# BUFFALO RUN ACRES SUBDIVISION

## CONSTRUCTION DOCUMENTS TAYLOR, WEBER COUNTY, UTAH

BUFFALO RUN ACRES SUBDIVISION  
CONSTRUCTION DOCUMENTS

CE2-02

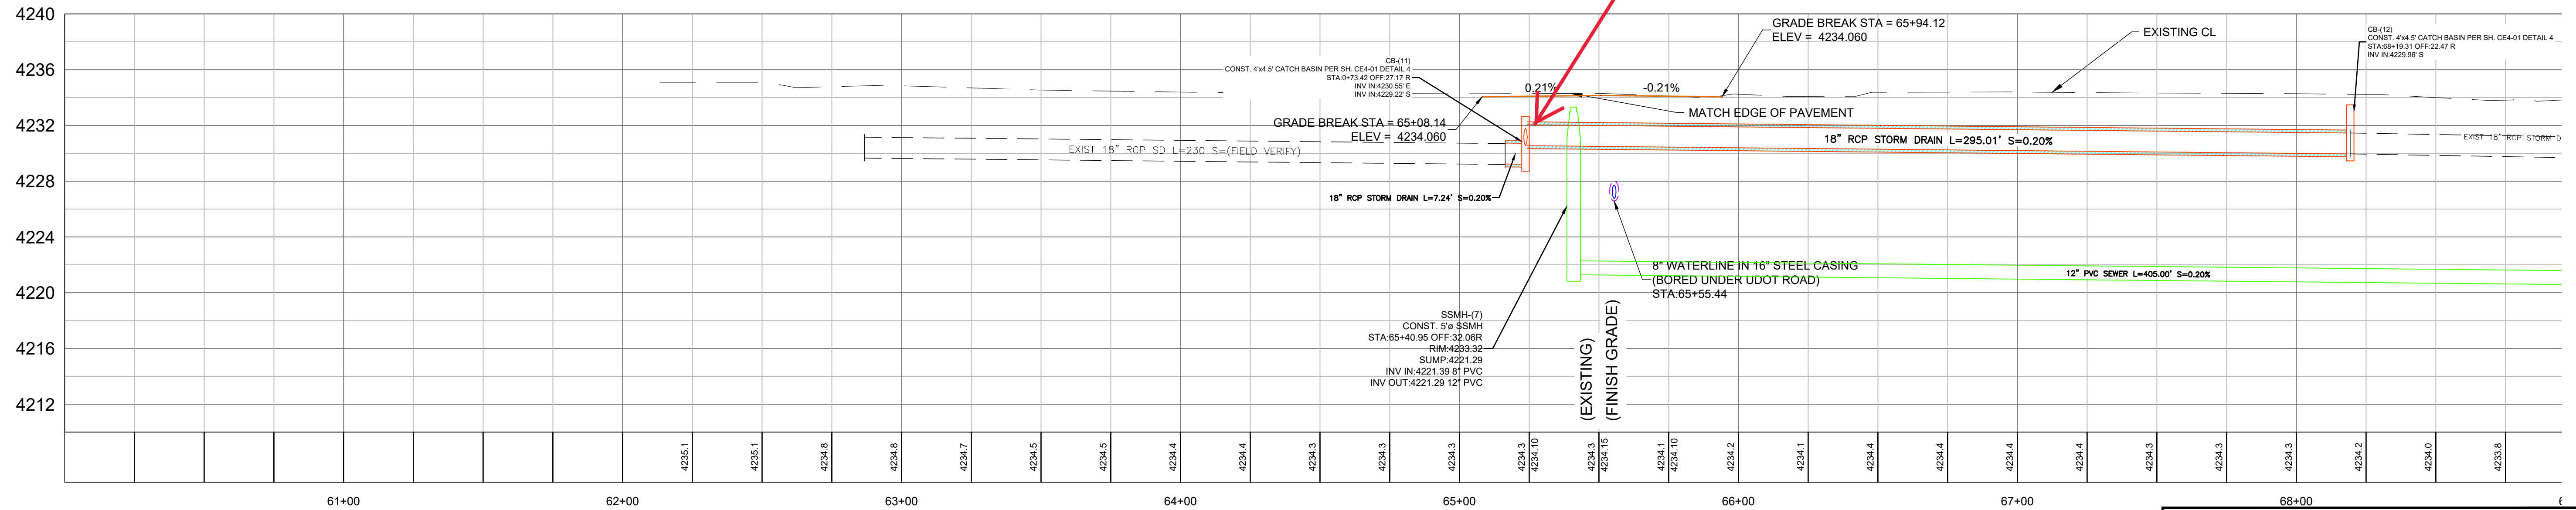
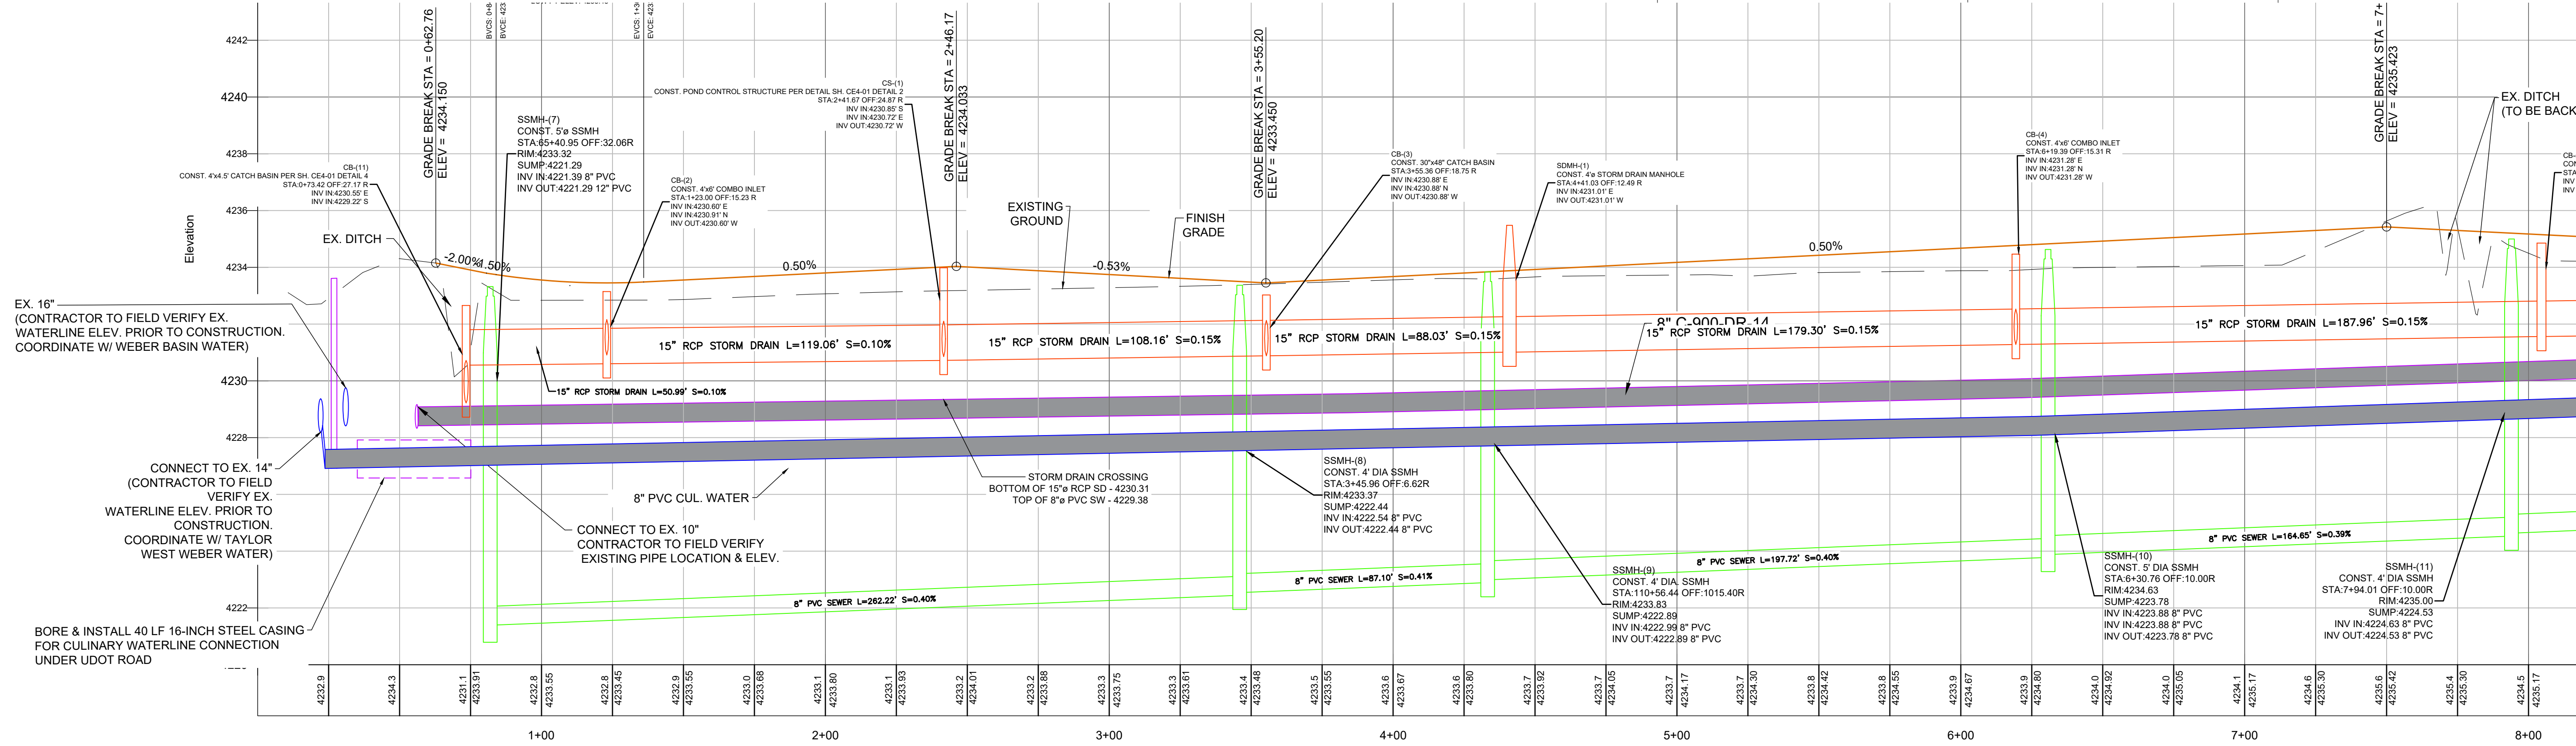
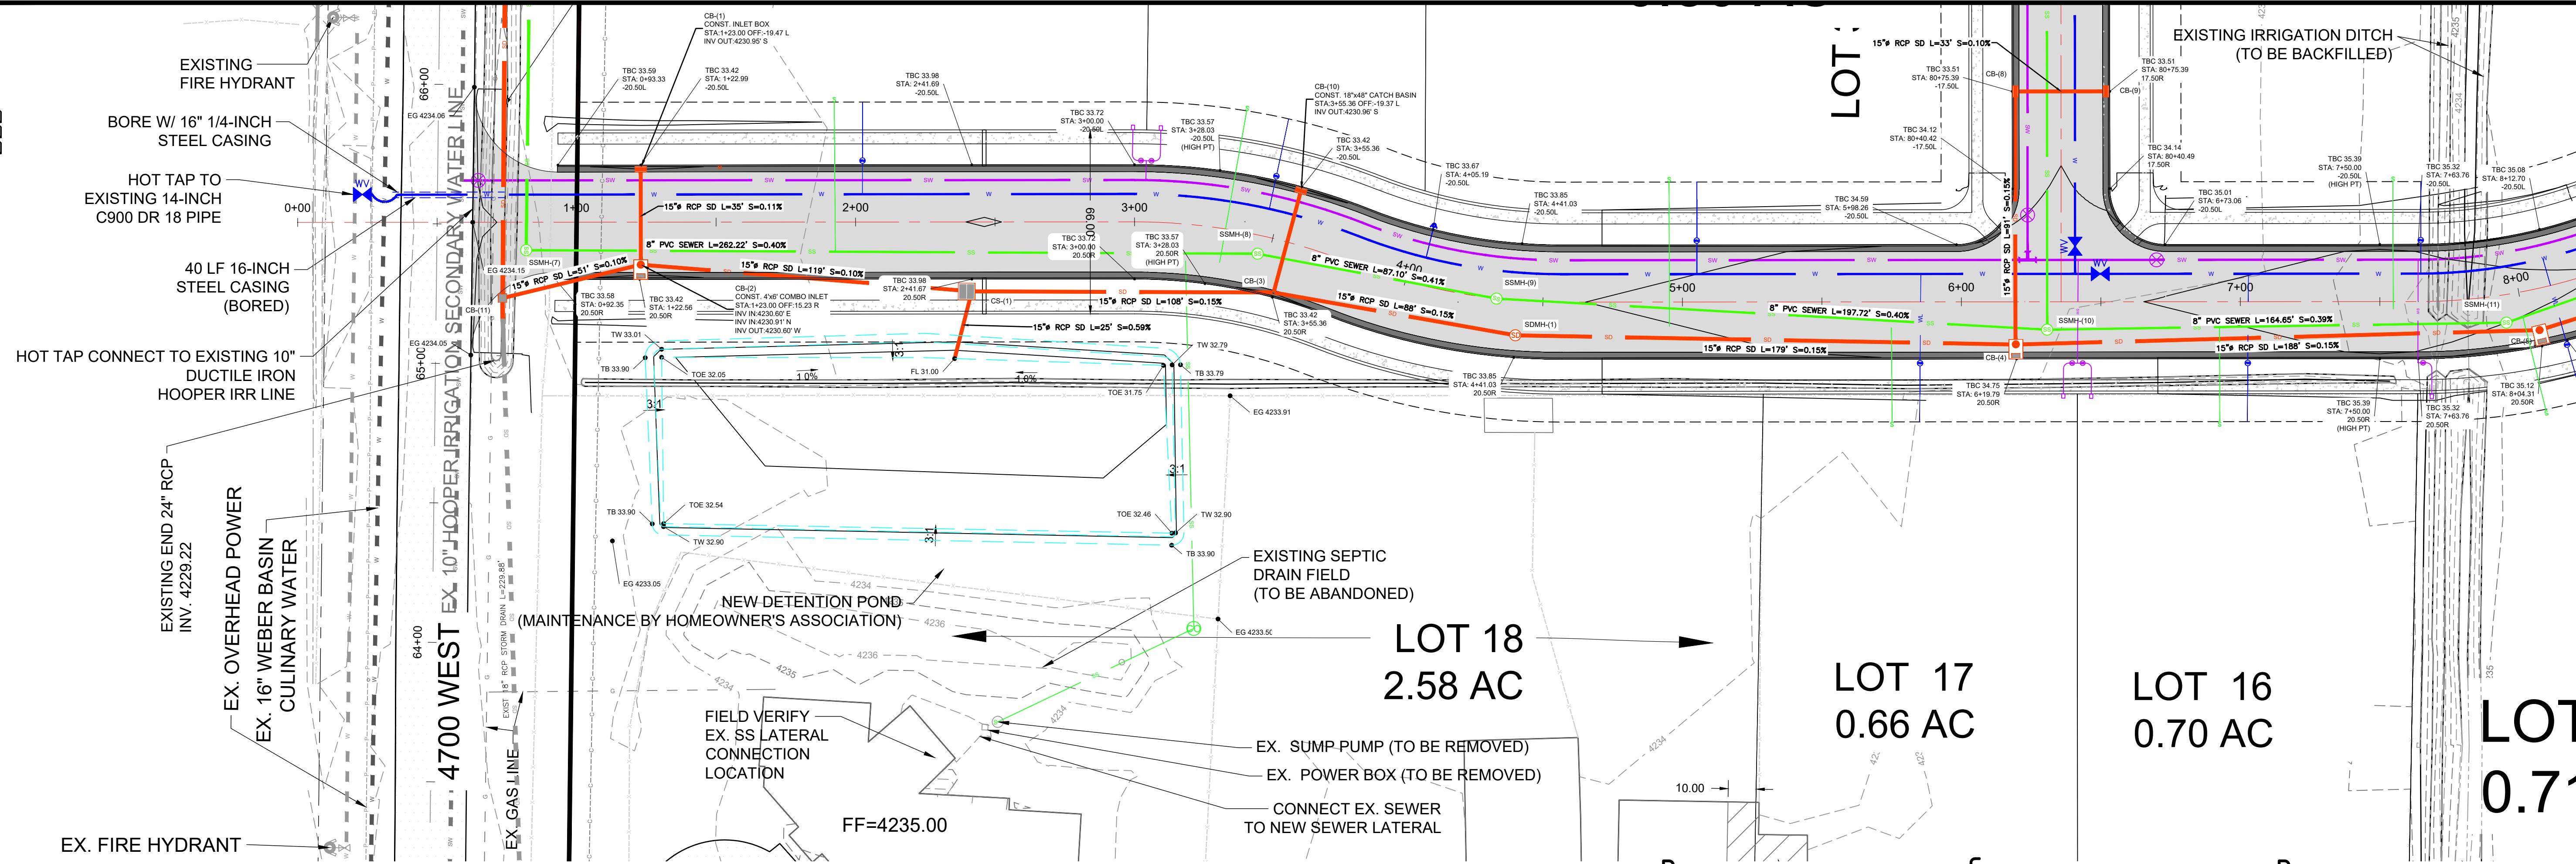
Can we add another box so that the water from the sub will go to the north. and if the water from the south needs to go north it can bubble up and go north?"

CE2-05

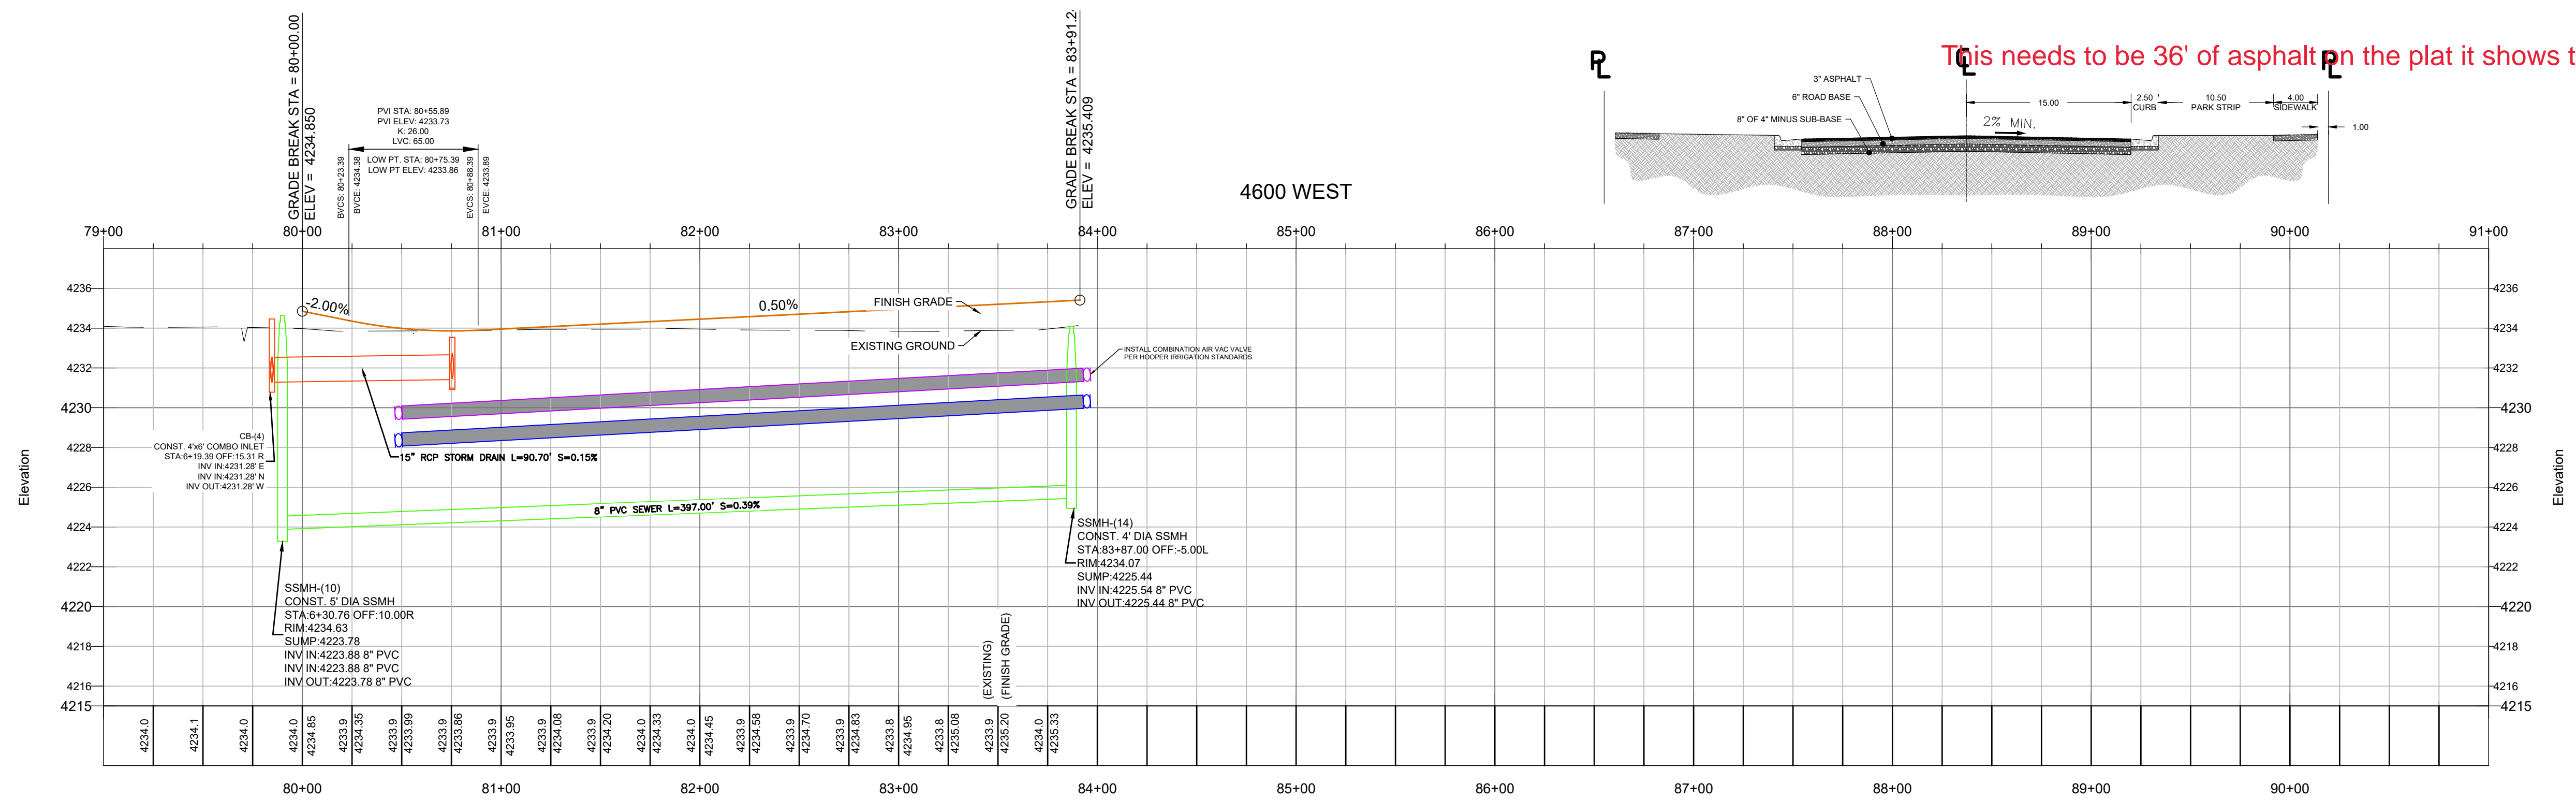
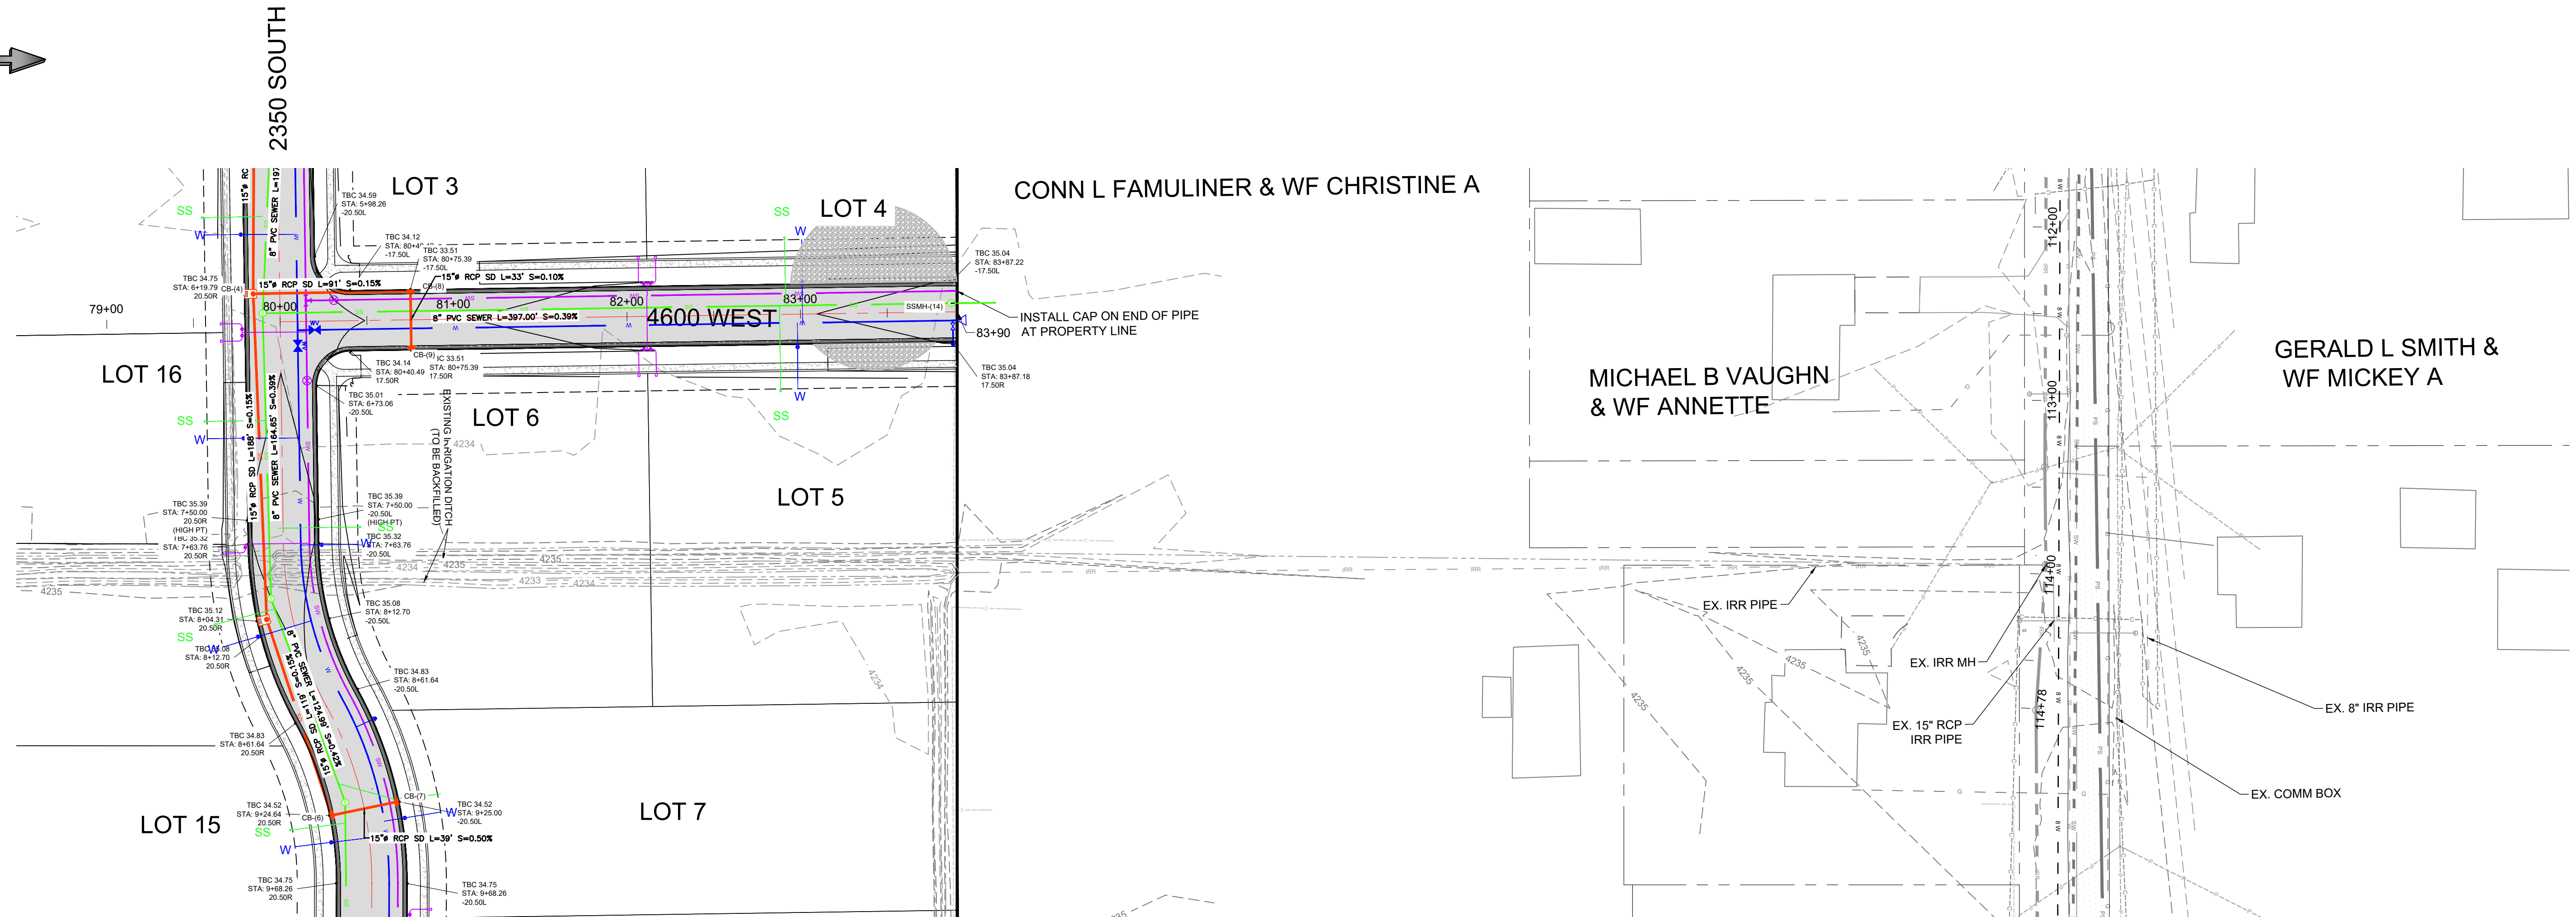
This needs to be 36' of asphalt on the plat it shows this as 60' ROW.
